SCHMIDT PUD DEVELOPMENT PLAN / PRELIMINARY PLAN

LETTER OF INTENT

MAY 2026

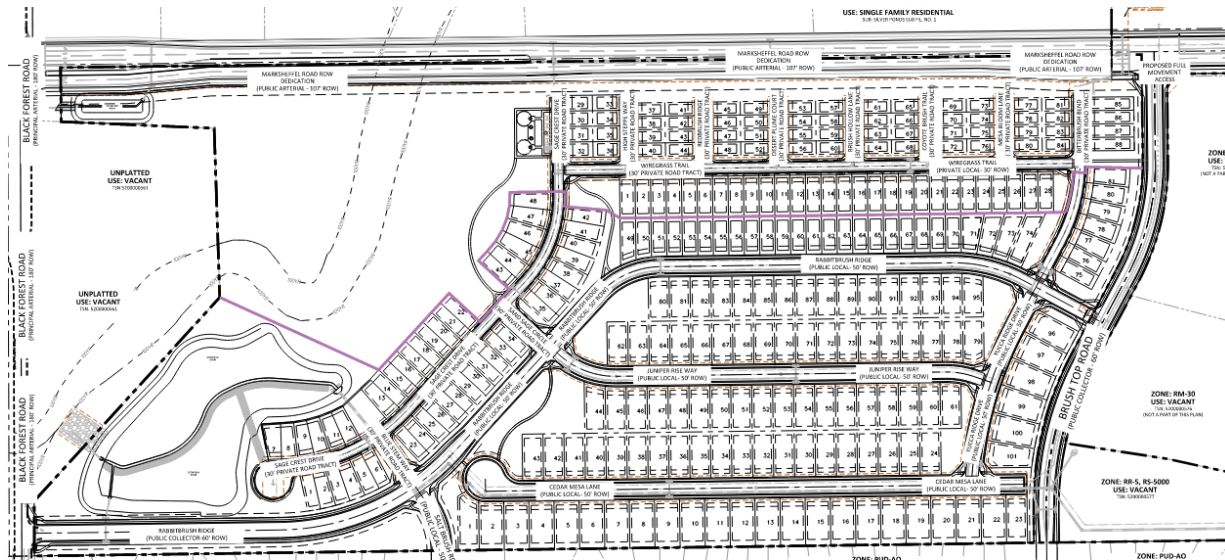
Add acreages for preliminary plan and add acreages for PUD. We can include it all in the same acreage just add that future development tract require a rezoning or a site specific PUD
